Luminaires V2.0 Stakeholder Meeting

April 20, 2015
1:30 pm - 4:30pm Eastern

Downlight Efficacy

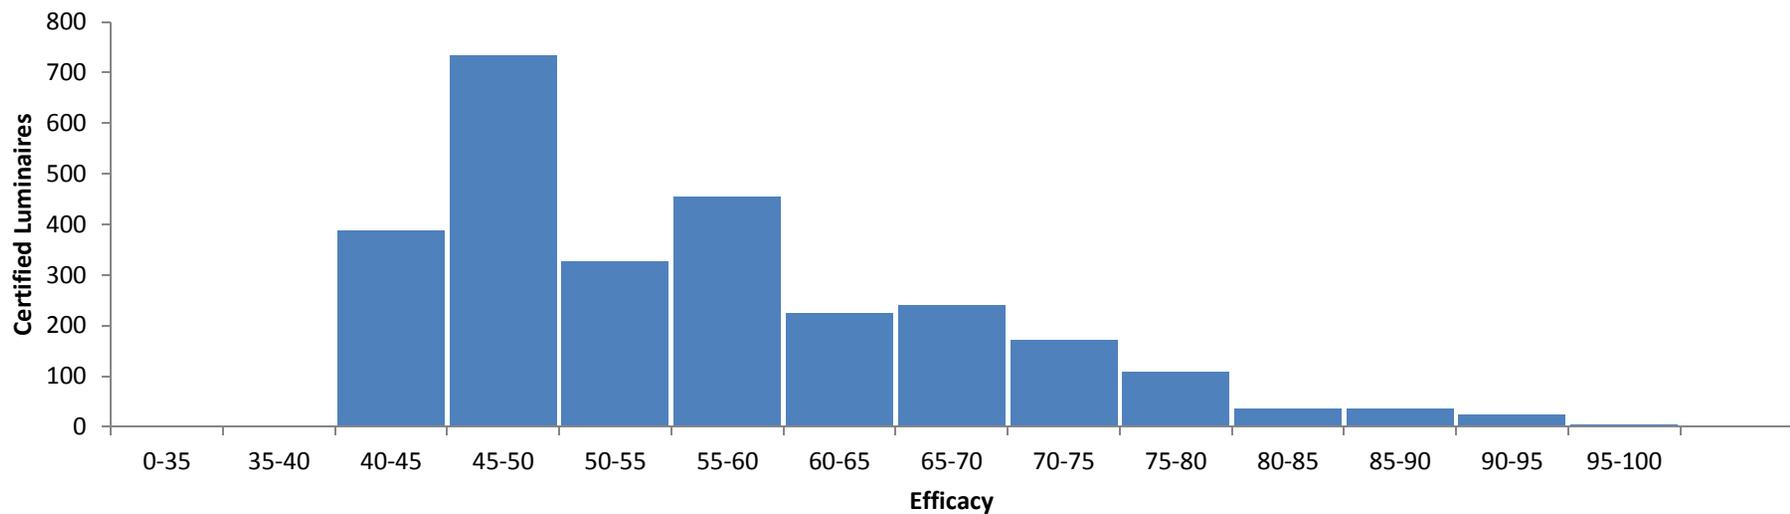
- Comment Received
 - A partner supports raising efficacy requirements to match current technology, but consideration should be given to support designs for quality of light; such as, but not limited to, high CRI and cut off angle provided by optical control and source regression. Considering only efficacy will encourage less desirable lighting solutions as there is a tradeoff between quality of light (including aesthetics) and efficacy. The partner recommended that the Luminaire efficacy for the Downlight luminaire type by reduced from 60lm/W to 50 lm/W.

Section 9.2 Efficacy: Downlight Retrofits

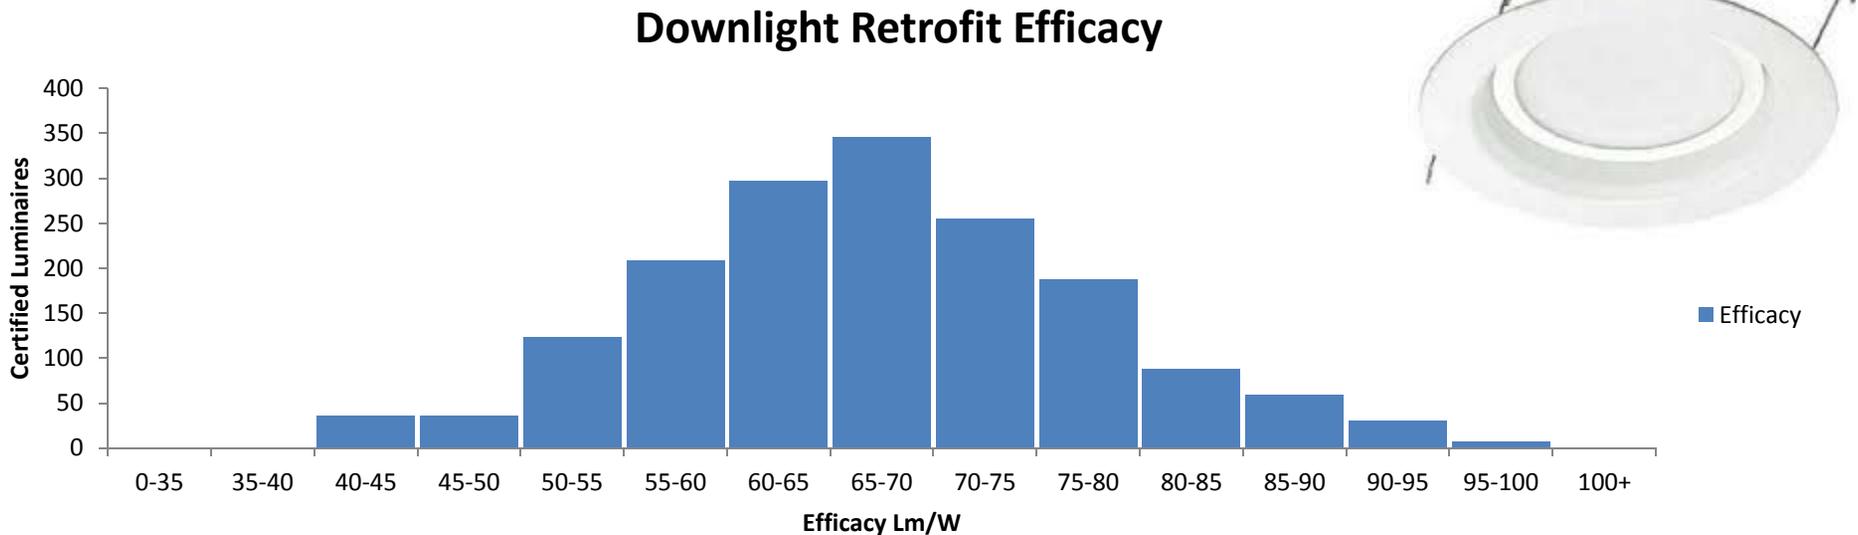
- Adjusted to 65 lm/W from Draft 1 level of 70 lm/W
- Comments received
 - A partner suggested that the levels were still set too high for popular low cost retrofit models.

Accent Light Efficacy

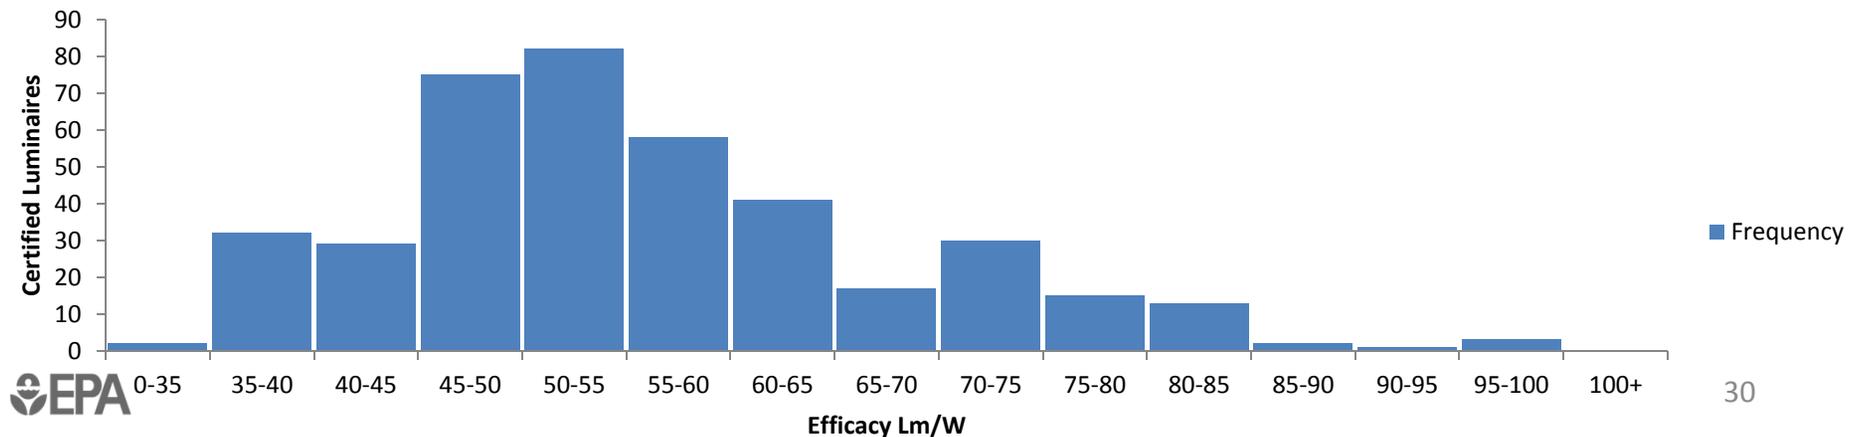
- Adjusted efficacy to 55 lm/W from Draft 1 level of 60 lm/W
 - 66 lm/W efficacy 2 years from effective date
- Comments received:
 - EPA should consider adjusting the zone to 0-60 degrees to allow for the inclusion of the most popular lighting effects used by designers.
 - Another manufacturer suggested that EPA align efficacy levels for accent lights with those of the Design Lights Consortium since this is an overlapping category and aligning the levels could reduce redundancy and eliminate testing and reporting burden.

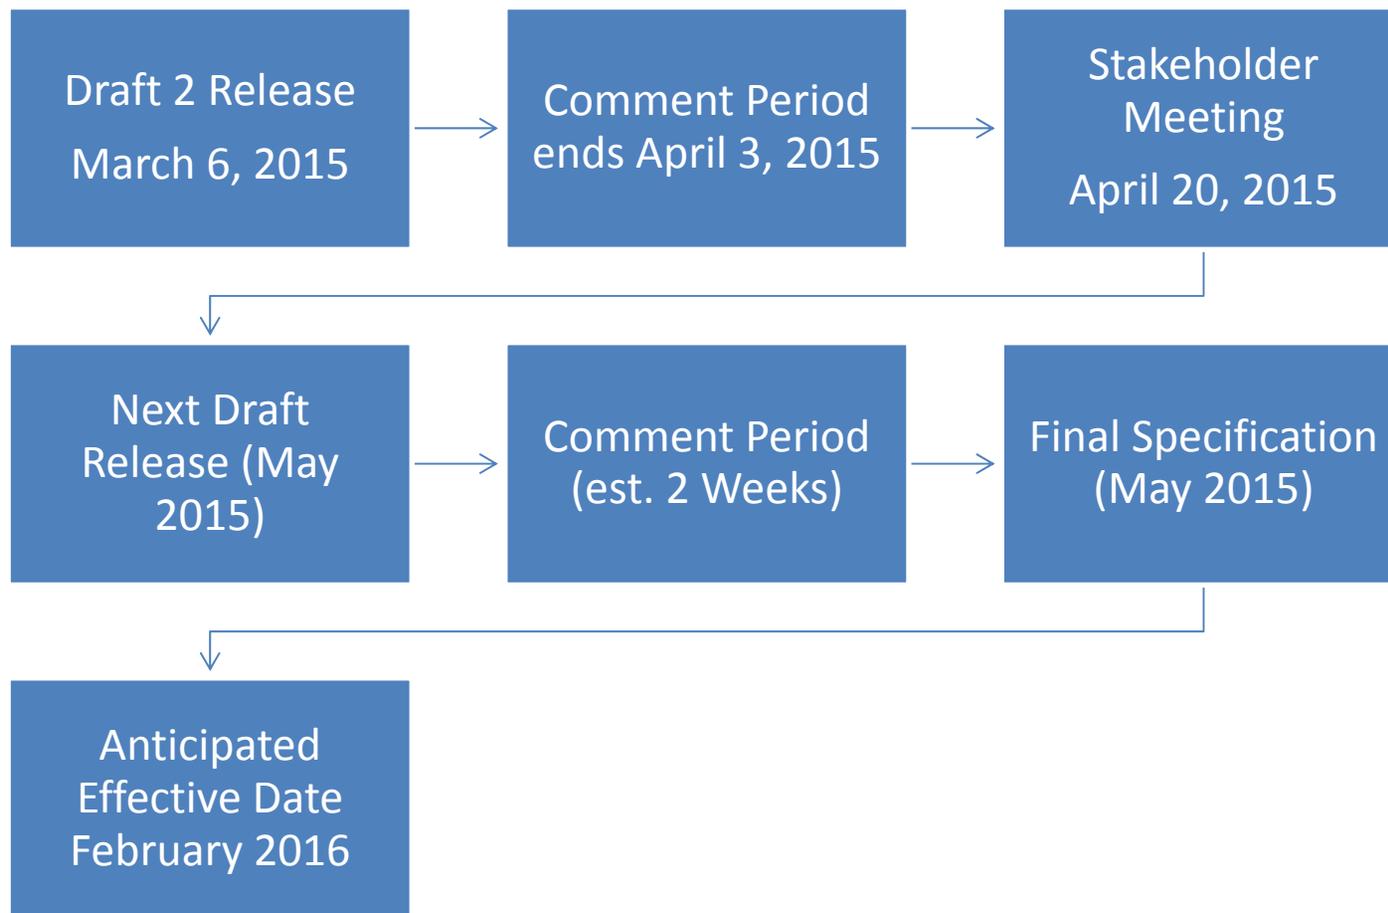
- Comment Received:
 - One manufacturer partner suggested that the light distribution depiction of directional luminaries needs to be described in more detail. The partner noted that light distribution is much more important during the specification and design process, these distribution sheets should be available on the manufacturer's website or in printed catalogs, and a drawing or diagram on the carton would only be visible after purchase for many luminaires. Additionally the partner noted that consumers and installers may not understand or find value in this information. EPA should consider how to make this more relevant to the application designer, installer and user.

- EPA Response:
 - EPA seeks stakeholder feedback on the depictions of light distribution – a suggestion that came out of the Oct 30th meeting.
